11-IEP-1C

EE History Discussion

CEC IEPR Workshop – May 25, 2011

Phillip Toth
Project Manager
Strategy, Planning & Analytics

Representation of IOU EE Savings Impacts are Misleading

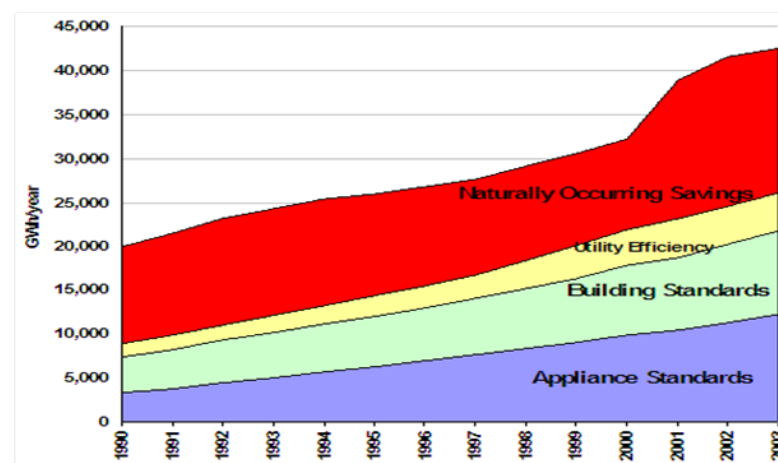
- The IEPR analyses is extremely misleading when it purports to allocate EE savings among mutually exclusive categories of utility and public agency programs, naturally occurring savings, and state and federal building codes and appliance standards
- A major function of EE programs is market transformation for EE technologies so the technologies become widely enough adopted to either:
 - 1) Gradually become the choice of many customers without the need for a utility program (“naturally occurring savings”) or
 - 2) Gain enough market share to be feasibly adopted into codes or standards
- Retract the inaccurate 2009 IEPR graph of historical EE
- If a graphic must be used to depict EE savings, SCE suggests depicting savings in total without savings attribution

For 2010-12 and beyond should there be a deterministic estimate or scenarios? Continued

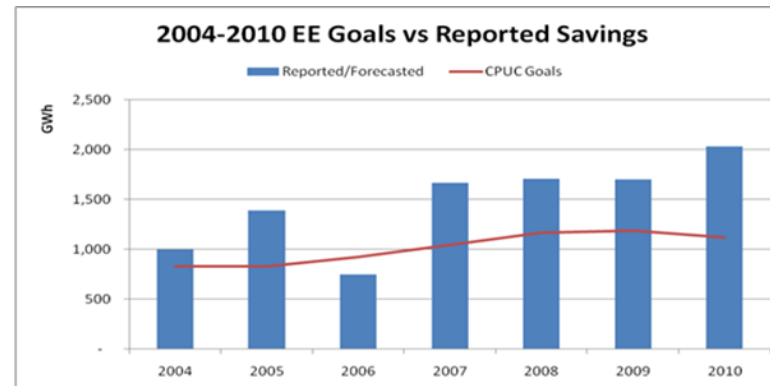
- 2013 and Beyond
 - SCE proposes bounding the EE scenarios with Low EE (High Demand), Mid EE (Mid Demand), and High EE (Low Demand) cases, reflecting the full range of uncertainties in the potential impact of different programs and strategies included in the TMG goals

- SCE is committed to meeting or exceeding the Total Market Gross goals as promulgated in D. 08-07-047
- SCE does not believe that the IOUs' ability to meet or exceed the EE goals is up for question. The question is how much EE can be realistically expected to occur in the context of the TMG goal era
